Access Compliance Report

Public Rights-of-Way

(Curb Ramps)

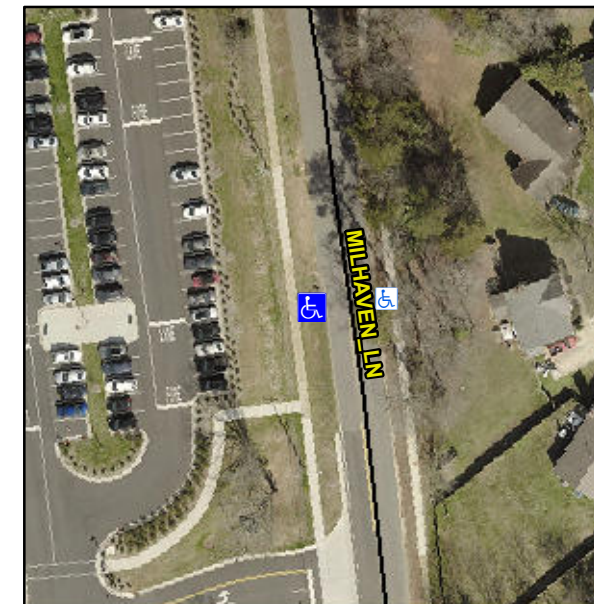
Intersection ID: 10016404	Main Street: MILHAVEN_LN	Cross Street: N/A	Location: W
ADA ID: 2ADF33ECE1A0	Ramp Type: Perp	Initial Pass/Fail: Fail	Overall Compliance: No
Severity Score: 13.75			
Codes/Mitigation Info/Possible Solution		Field Measurements/Component Compliance

R304.2.2

Remove & Replace Entire Ramp.
